CITY OF ST. HELENS PLANNING DEPARTMENT

MEMORANDUM

TO: Planning Commission acting as the Historic Landmarks Commission
FROM: Jennifer Dimsho, AICP, Associate Planner
RE: 343 S. 1st Street
DATE: February 16, 2023

Dave Lauridsen (Crooked Creek Brewery) submitted a Site Development Review (Minor) and a building permit (Permit No. 749-23-000063-STR) to do several interior and exterior modifications to 343 S. 1st Street, the current location of Dockside restaurant.

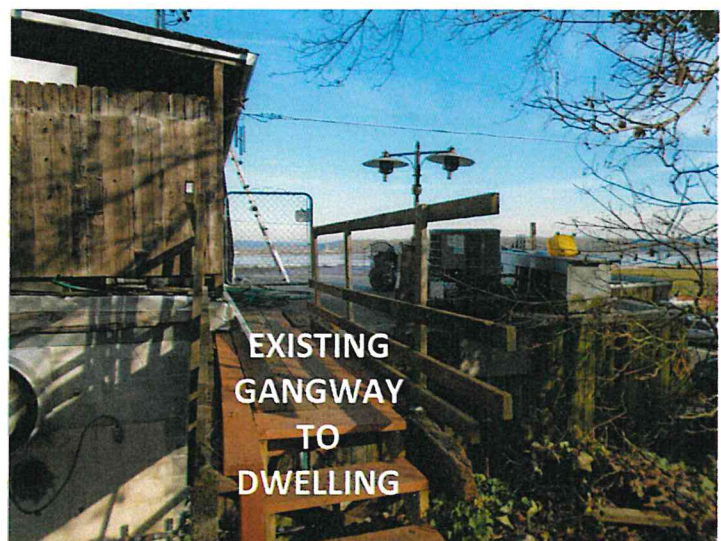
The applicant is proposing removal of a 46-foot-long awning which spans most of the front façade. They are also proposing replacement of the main entry awning because it is in poor condition. Lastly, they are proposing a new awning over the new entry to the existing 2nd floor dwelling. The Guidelines encourage the use of awnings because they promote a more friendly pedestrian environment in the elements (sun and rain). The applicant believes the large awning was installed during the 1985 expansion. The

applicant states the reason for removal is to bring more light into the dining area by installing larger windows. They also propose outdoor sidewalk dining. **Does the Commission feel that the awning changes are consistent with the Guidelines?**

Building Façade/Entry

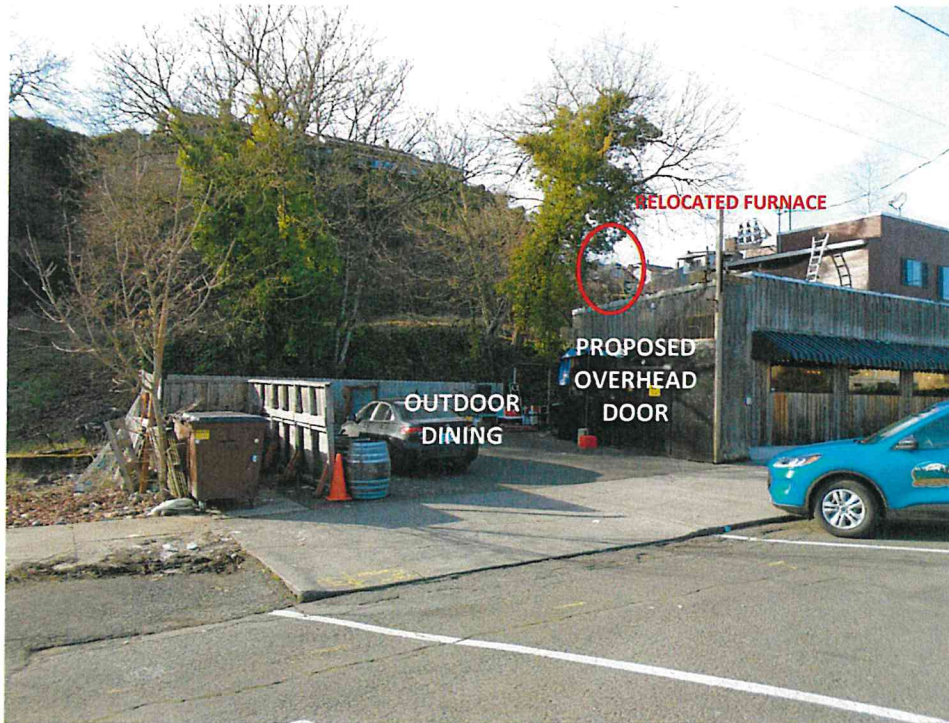
The Guidelines promote the preservation or restoration of the original building façade. The applicant is proposing to replace the existing wood siding with a similar wood, vertical shiplap siding material which will be painted a dark neutral color instead of stained. Based on the 1985 SDR, it appears the existing siding was installed as part of the 1985 remodel. The applicant states that the lack of maintenance and flashing has caused areas to rot so badly that it is beyond repair. **Staff feels that replacement of a similar siding is consistent because restoration of the existing siding is not possible.**

The Guidelines state that new entry doors should incorporate a large window and a solid kickplate. The applicant states the door will be replaced with a single lite wood and glass door with a kick-plate that is consistent with other entry doors. **This new door does not show a kickplate. Staff recommends a condition to ensure the new door includes one.**

There is a new north-facing entry proposed to the 2nd floor dwelling which will require a new staircase along the north façade. The applicant is proposing a 6' high privacy fence with a gate at this entry. The existing entry to the dwelling crosses a gangway and onto the roof (pictured right) which can be removed with the new side entry and staircase proposed.

The applicant is also proposing a new overhead door on the south-facing wall out into an outdoor dining area. This overhead door is non-traditional design for a new door/entry. The applicant states this is in effort to bring in more natural light into the dining area and better enhance the connection between the indoor/outdoor dining areas. A photo of this area is included below. **Does the Commission feel comfortable with a new non-traditional entry at the south facade?**

Material & Building Colors

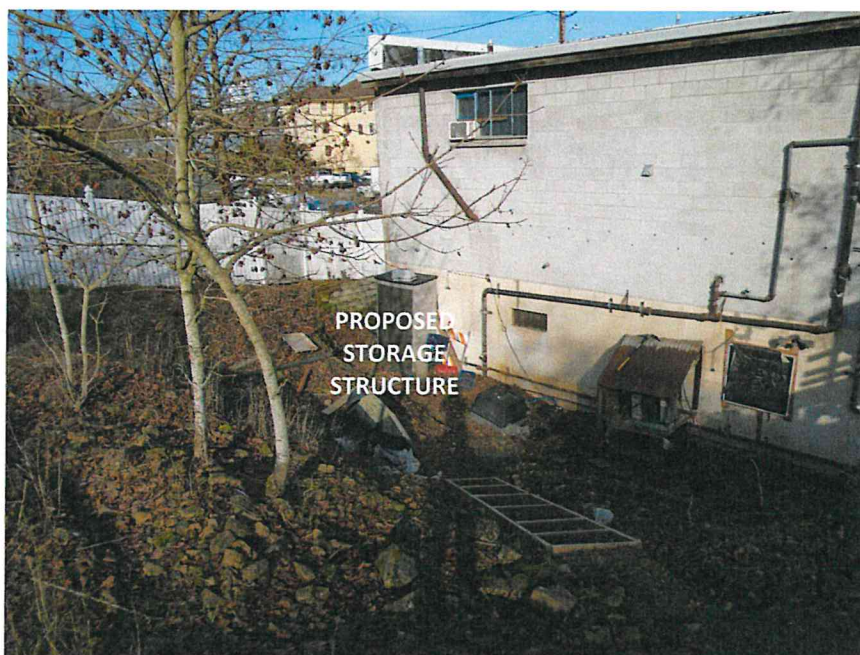
The Guidelines state that when wood siding is used, it should be painted using a palette of earth tones or muted colors. The Guidelines further state that paint color is the owner's decision, but painting a structure to be a good neighbor is encouraged. **Staff feels the applicant's proposal for a dark neutral color complies with the Guidelines.**

The applicant is relocating an existing furnace to the southwest corner roof. Even though it is located in a location that is as far from S. 1st Street as possible, it will still be visible from the street below (pictured on previous page). **Staff is recommending screening for this mechanical unit.**

front (east) elevation

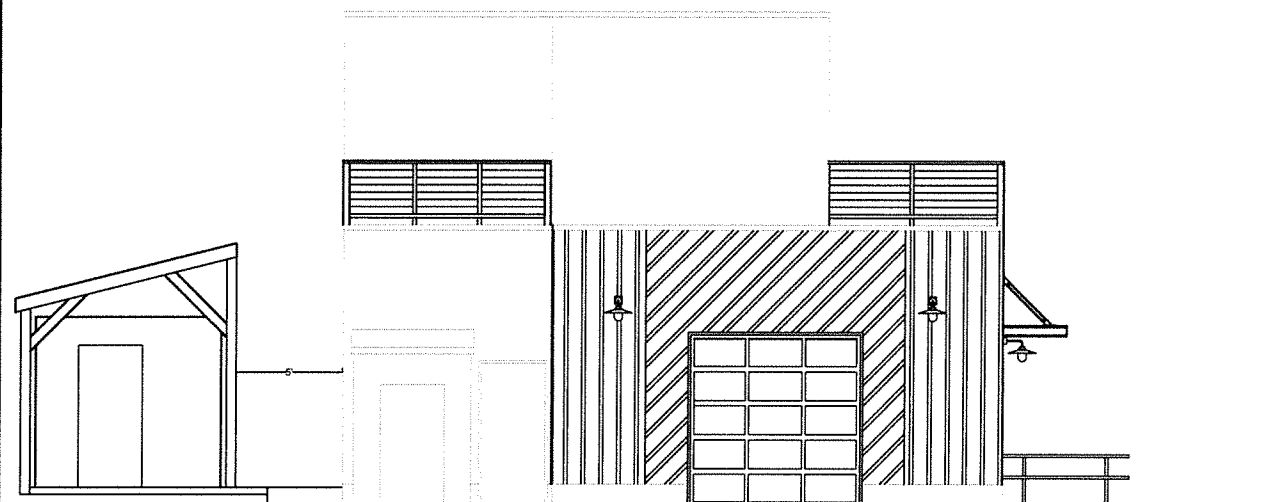
The applicant is proposing to replace all the existing 4' high windows along the front façade so that they are a maximum of 6' in height. The window width will remain at 8' wide. The Guidelines encourage maximizing the window-to-wall ratio of the ground-floor by increasing the visual connection between the sidewalk and the interior of the restaurant. Staff feels replacement with taller windows does this.

The window frames will be a commercial-style aluminum or a fiberglass style frame. **Although the applicant is changing the size of the windows and replacing original windows (which the Guidelines**

discourages), the Commission must decide if the proposed 1st floor window replacements comply with the Guidelines for other reasons described above.

The applicant is also replacing the 2nd floor residential windows with a similar look and style of the ground floor windows, although the dimensions will be the same as what is existing. The Guidelines encourage upper-story windows to have a vertical emphasis, or to be twice as tall vertically as they are wide to represent a more traditional design. They should also be placed symmetrically. There are also existing shutters on the 2nd floor windows, which the applicant does not address whether these are to be removed or to stay. Does the Commission want to make any recommendations regarding the upper story windows to better comply with the Guidelines?
